PINE VALLEY SUBDIVISION, **RESUBDIVISION OF**

APPLICATION NUMBER 25 DATE May 6, 2004

PINE VALLEY SUBDIVISION, RESUBDIVISION OF

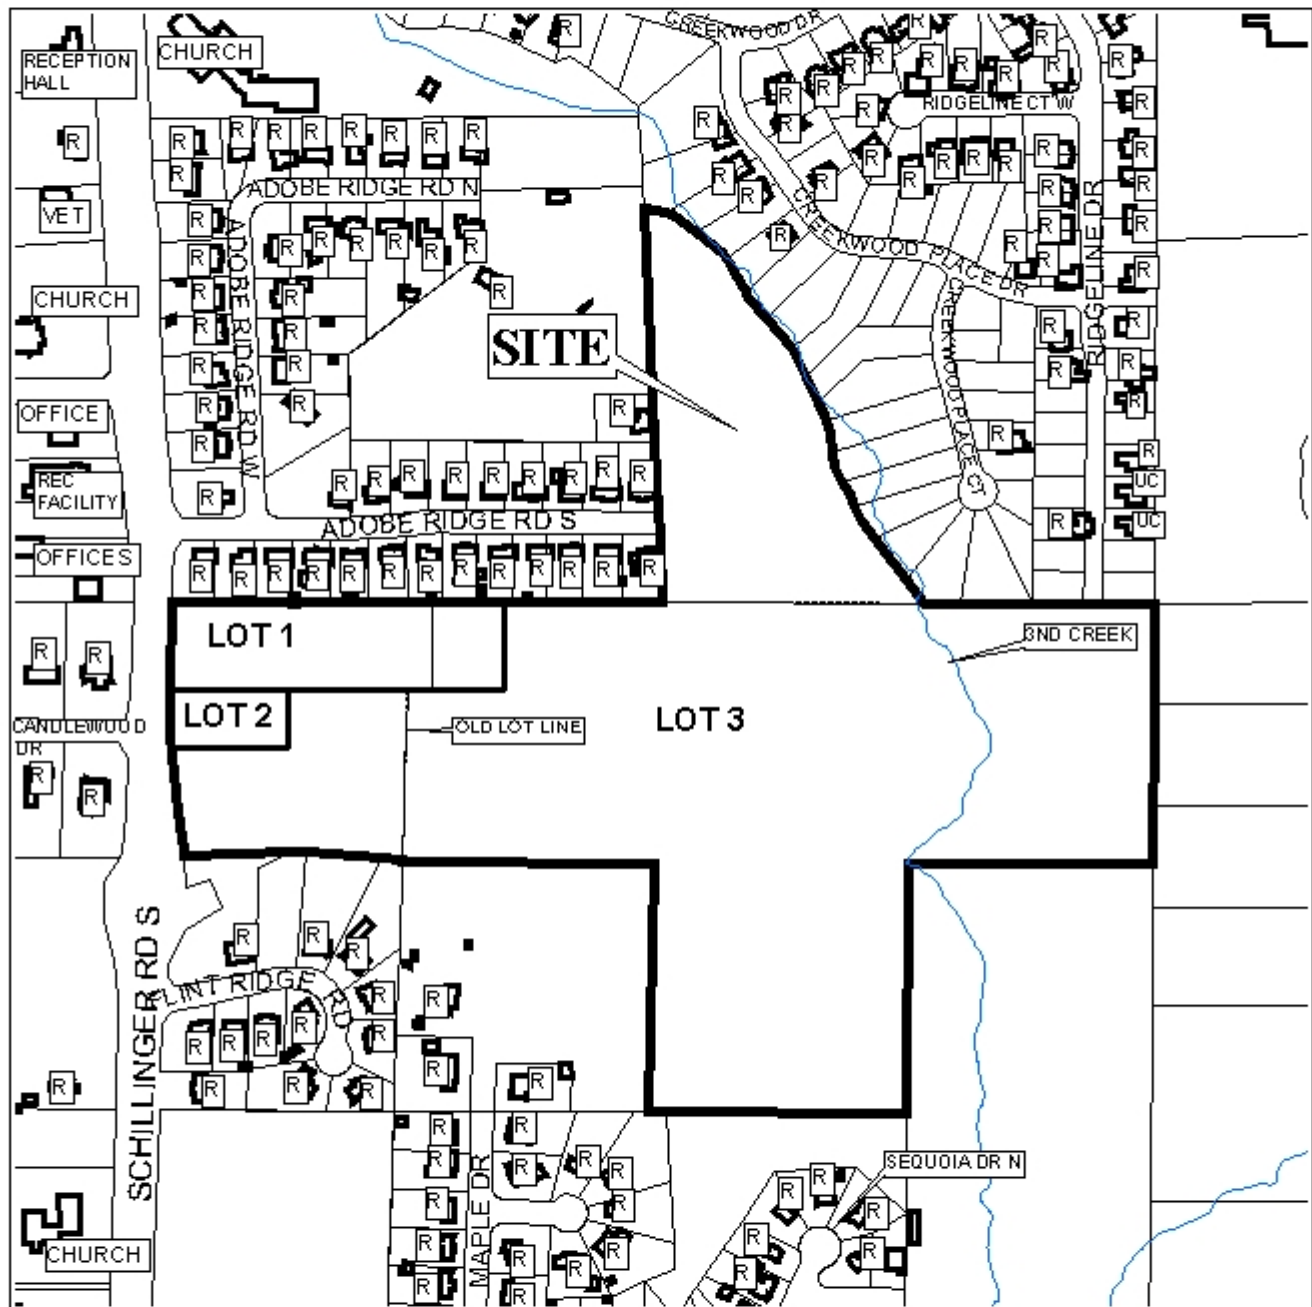
Schillinger Road, which is illustrated having a variable right-of-way, is shown as a major street on the Major Street Plan, and as such requires a 100-foot right-of-way; therefore, the dedication of sufficient right-of-way to provide 50-feet from the centerline of Schillinger Road, should be required. With the site being located on a major street, access management is a concern; therefore the placement of a note on the final plat stating that each lot is limited to one curb cut to Schillinger Road, with the size, location and design to be approved by County Engineering, should be required. Furthermore, as Lot 3 would have frontage along Schillinger Road, Adobe Ridge Road South, and Ridgeline Road, the placement of a note on the final plat stating that Lot 3 is denied access to Adobe Ridge Road South and Ridgeline Drive, should be required.

As proposed, Lots 1 and 3 would exceed the maximum width to depth ratio; therefore, a waiver of Section V.D.3., would be required.

The 25-foot minimum building setback line is not shown but would be required on the final plat.

With a waiver of Section V.D.3. the plat will meet the minimum requirements of the Subdivision Regulations and is recommended for Tentative Approval subject to the following conditions: 1) the dedication of sufficient right-of-way to provide 50-feet from the centerline of Schillinger Road; 2) the placement of a note on the final plat stating that each lot is limited to one curb cut to Schillinger Road, with the size, location and design to be approved by County Engineering; 3) the placement of a note on the final plat stating that Lot 3 is denied access to Adobe Ridge Road South and Ridgeline Drive; 4) the placement of a note on the final plat stating that if any property is developed commercially and adjoins residentially developed property, a buffer in compliance with Section V.A.7. of the Subdivision Regulations, will be provided; 5) the

developer obtain any necessary federal, state, and local environmental approvals prior to development; and 6) the placement of the 25-foot minimum building setback line on the final plat.
